Site Audit Report

Former Sewage Treatment Plant and Landfill 2, Former Schofields
Aerodrome, Triton Parade, Nirimba Fields, NSW 2763

Audit Number: MP169_04

6 March 2023

Figure 3 : Schofields PFAS STP/LF2 Soil Sample Exceedances

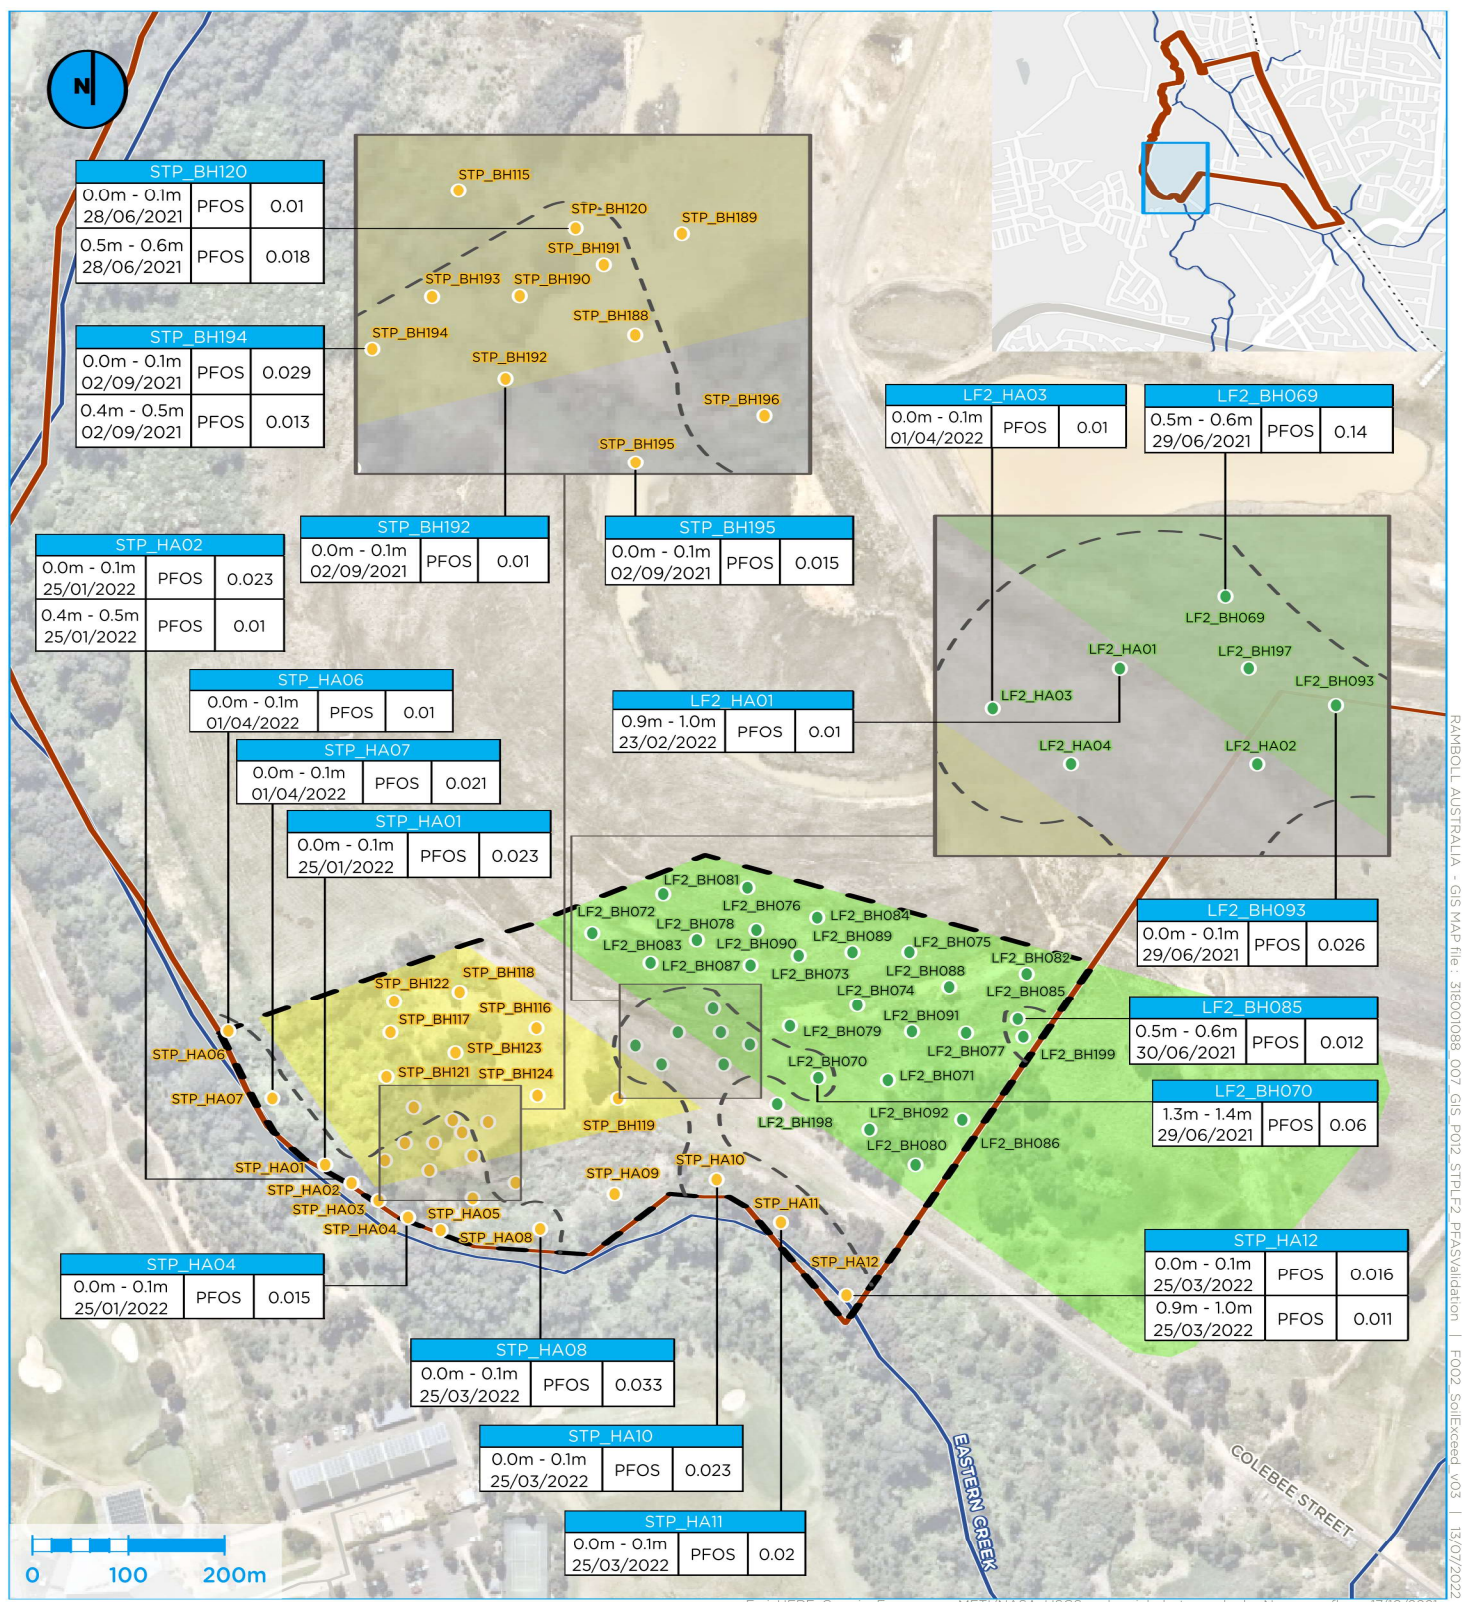
19. **Section 9.1:** As indicated in Figure 3, the soil sampling locations with elevated results are located around the west, south-west and south of STP and Landfill 2 towards the boundary of the site at Eastern Creek (not just at the southern portion of Landfill 2).

24. Figure 3 Soil Sample Exceedances:

Figure 4 : Schofield's PFAS STP/LF2 Soil Leachate Exceedances

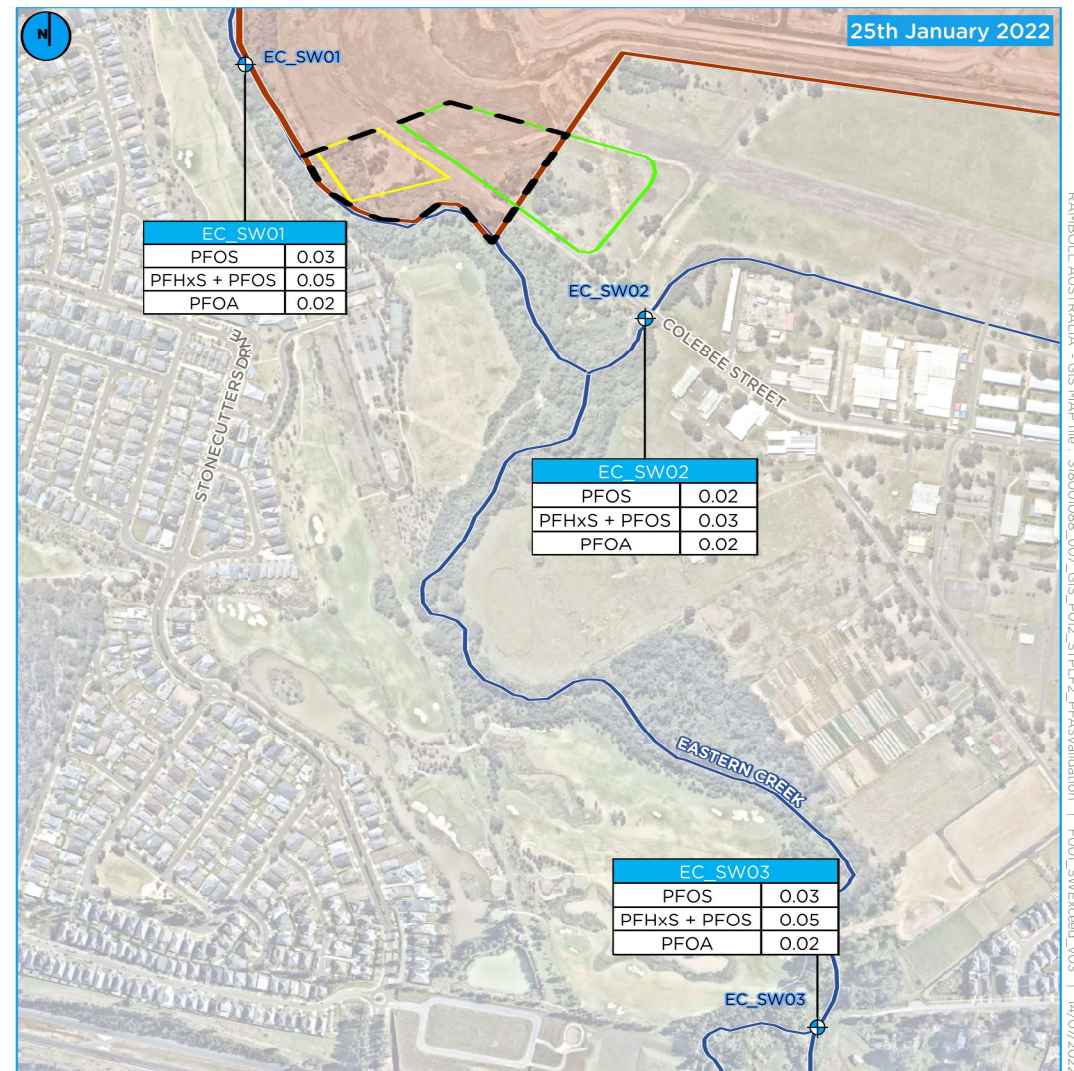
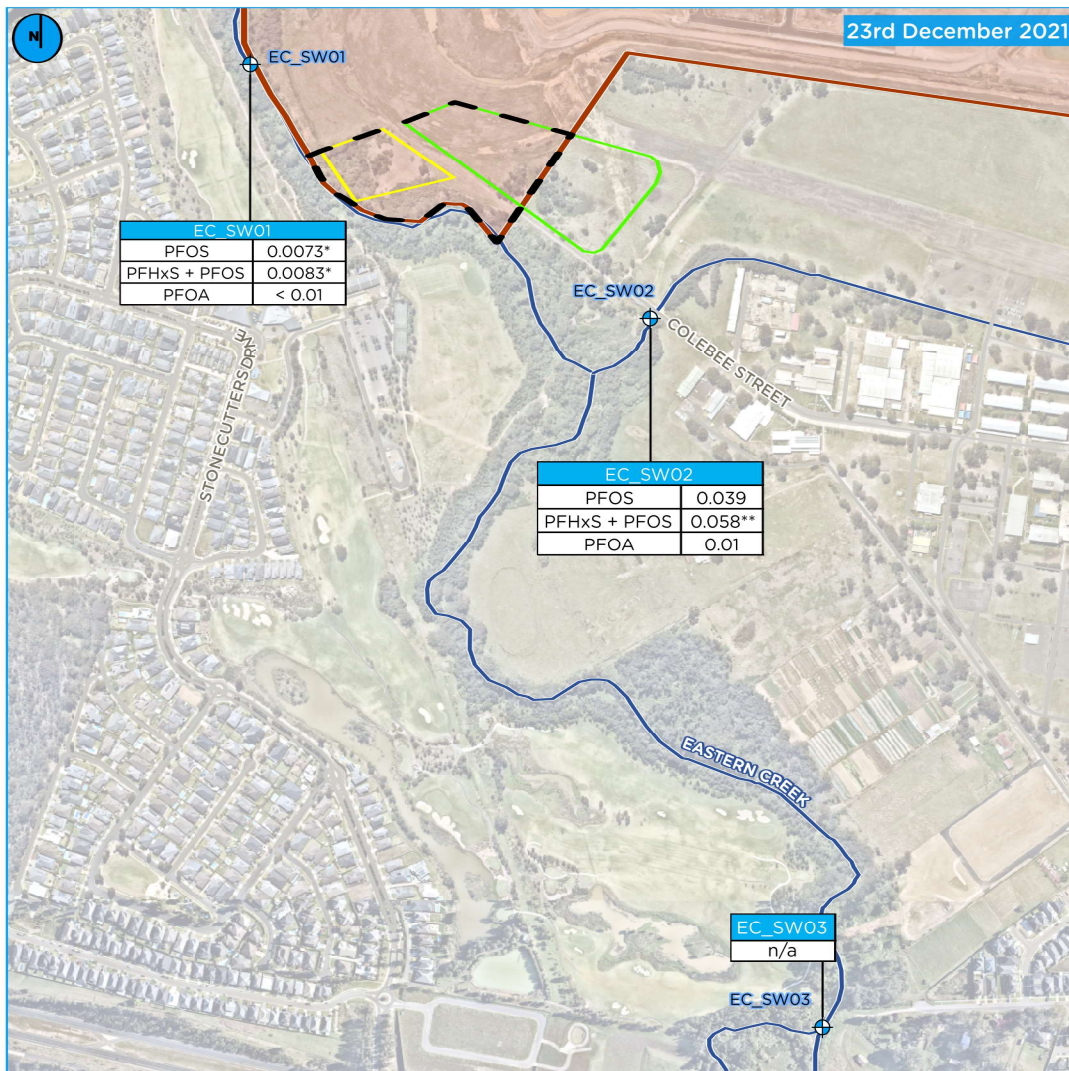
27. Section 11: Should soil leachability results (refer to Section 9.2.3) and Figure 4 be discussed?

28. Figure 4 Soil Leachate Exceedances:
